Recycled Water Reuse Program
Idaho Department of Environmental Quality
Coeur d'Alene Regional Office

Bayview Water and Sewer District
2018 Annual Report Review

Date Completed: January 23, 2019

Reuse Permit: Annual Report Review Form

Figure 1 – Recycled water volumes (MG)

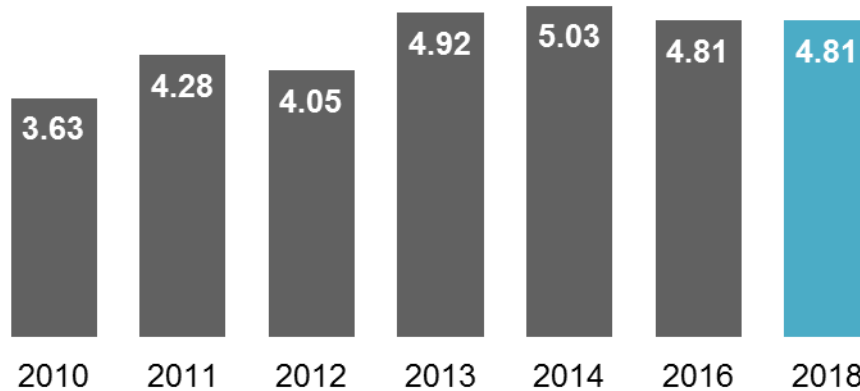
Comments: The permittee irrigated nearly 4.81 million gallons (MG) of recycled water during the 2018 irrigation season (Figure 1).

Figure 2 – 2018 HLRs compared to the IWR for MU-010501

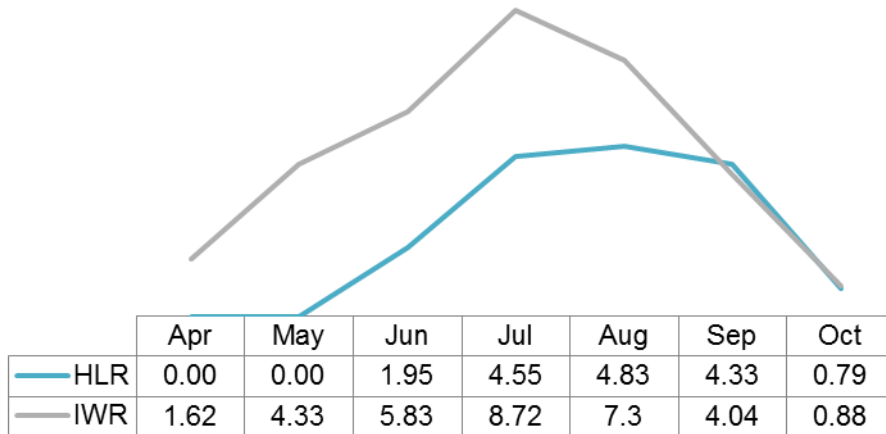
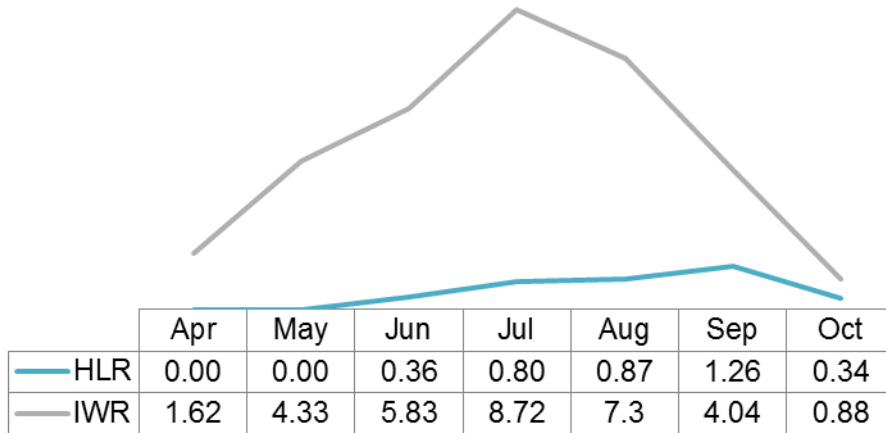
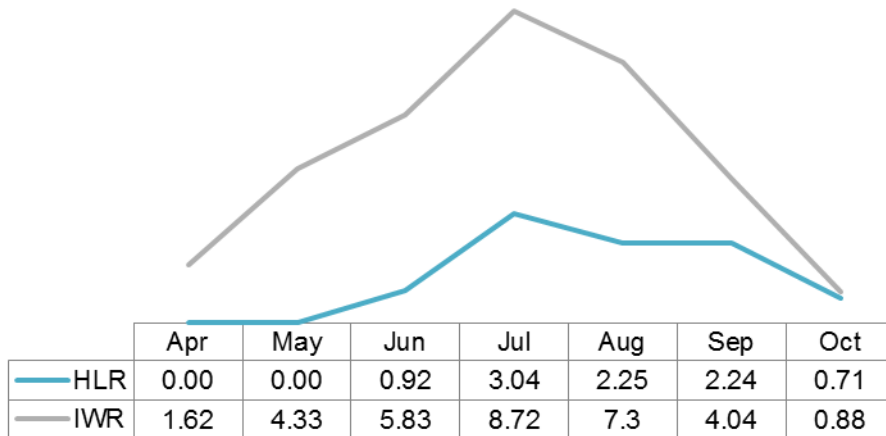
Comments: Hydraulic loading rates (HLR) for each management unit are substantially at or below the irrigation water requirement (Figure 2-4). This is acceptable for a forested site. Operator records show that each management unit is made up of two or three independent zones. Future annual reports should include the approximate area for each zone for recording purposes.

Zone acreage – DEQ is requesting future annual reports include the zone acreage for a better understanding of how irrigation occurs between each zone and how it relates to the hydraulic loading rates reported for each management unit.

Figure 6 – DEQ total nitrogen loading assessment for the 2018 growing season.

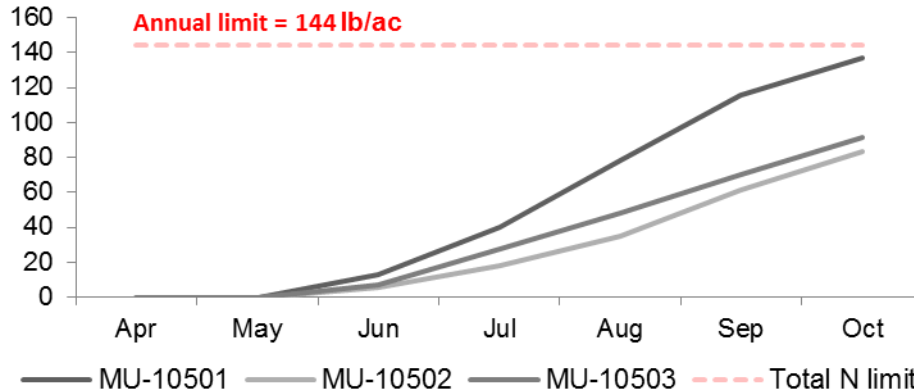
Comments: Total nitrogen loading rates for each management unit were less than the total nitrogen limit of 144 lb/ac for the 2018 growing season (Figure 6).

Figure 7 – Typical nitrogen concentrations from 2013-2018 compared to the 2018 values for each month.

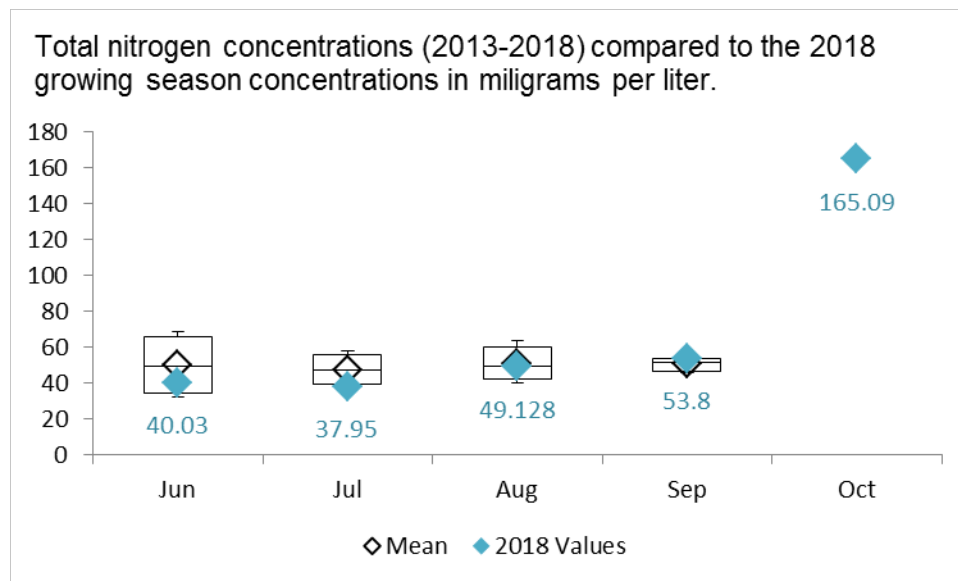
Comments: DEQ staff compared the constituent concentrations reported in 2018 to the historical data (Figure 7). It should be noted, this data set is not complete at this time.
